SUBJECT: TEDS Exception for Proposal for Machine Shop located

at 3172 Pipe Court

DESIGN EXCEPTION #DE 7-05

Driveway Offsets - Section 4.1.2

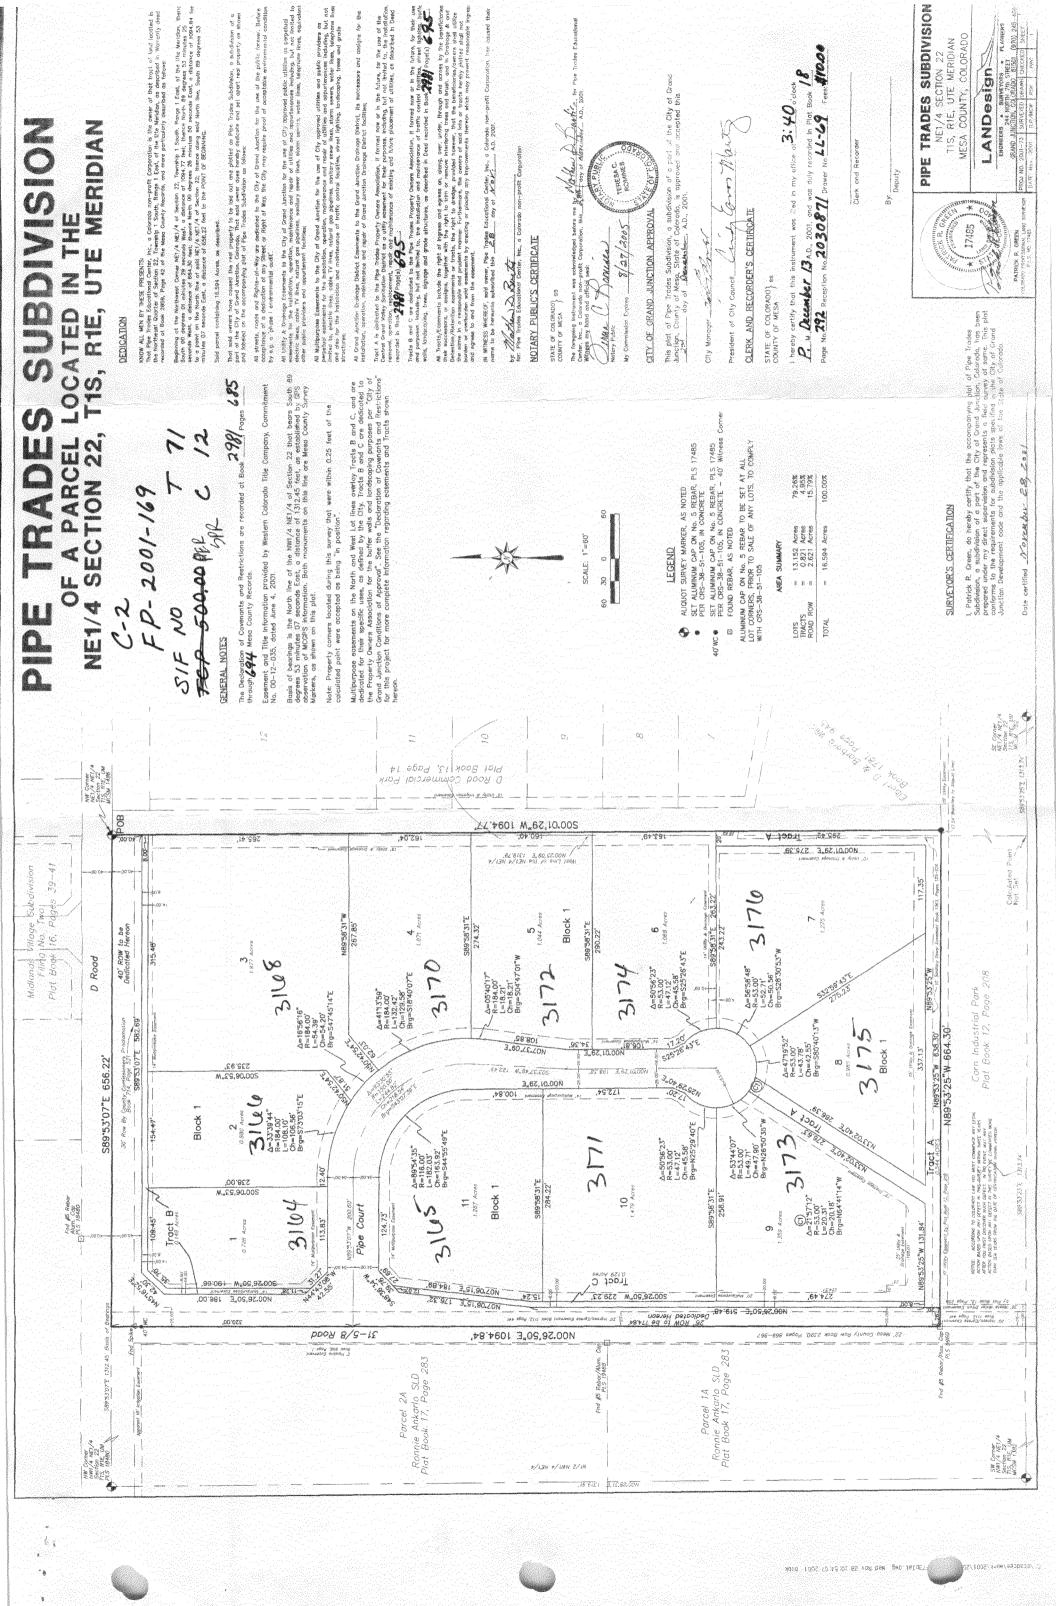
Alternatives Considered – Locating the proposed building to face the street was considered, but due to the future, shop expansion of the building, the building would be too wide to allow access to the rear portion of the Site. Moving the building further to the rear of the Lot was also considered. This resulted in a long winding access drive into the lot as well as cutting into the space for future development. Mirroring the building would not work due to the Owner's need for a Southern exposure for his building.

<u>Proposed Design</u> – The proposed design is to keep the present Site design as was originally submitted, and request a TEDS exception. Attached is a copy of a Site Plan of the proposed design for this property. The owner is willing to move the Site layout 10 feet further to the North if this would be helpful in obtaining TEDS exception.

Staff does not believe this exception would result in future safety issues, however, because other options do exist to conform to the requirements of TEDS, we cannot recommend approval.
